REMARKS

AMENDMENTS TO THE DRAWINGS

The attached "Replacement Sheet" of drawings includes changes to Figure 1. The attached "Replacement Sheet," which includes Figure 1, replaces the original sheet including Figure 1.

FIG. 1.

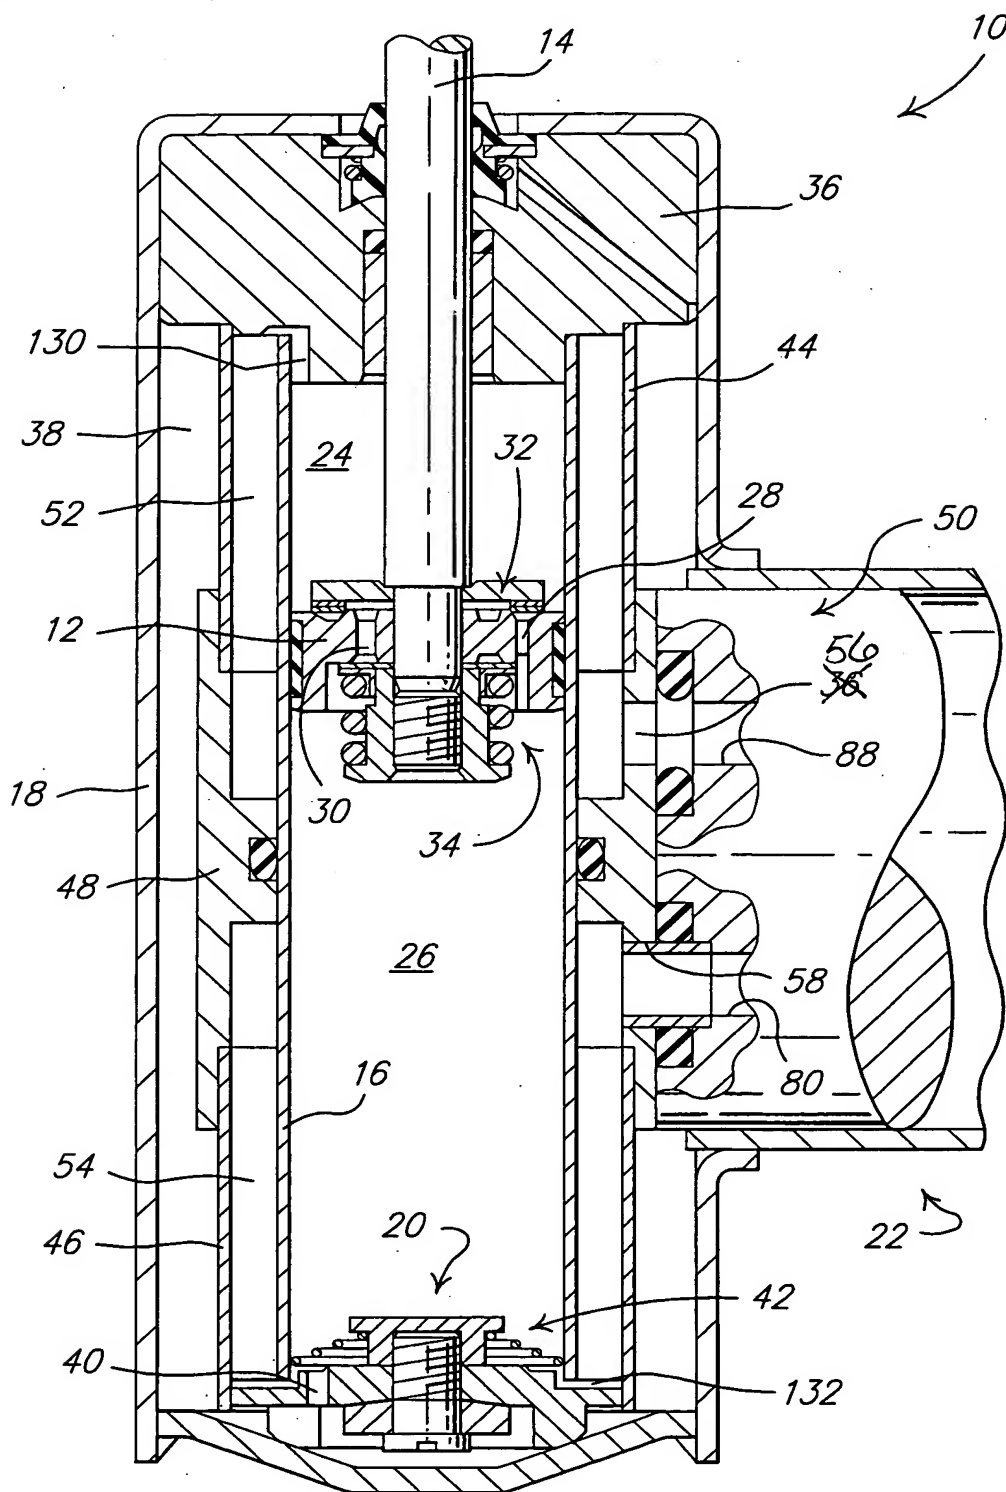
The drawings are objected to as failing to comply with 37 CFR 1.84(p)(4) because reference character "36" has been used to designate both the rebound outlet and the guide rod in figure 1. Figure 1 has been amended to illustrate the rebound outlet as being reference numeral 56 which is consistent with the specification. Withdrawal of the objection is respectfully requested.

Figure 1 – Please change reference numeral 36 to 56.
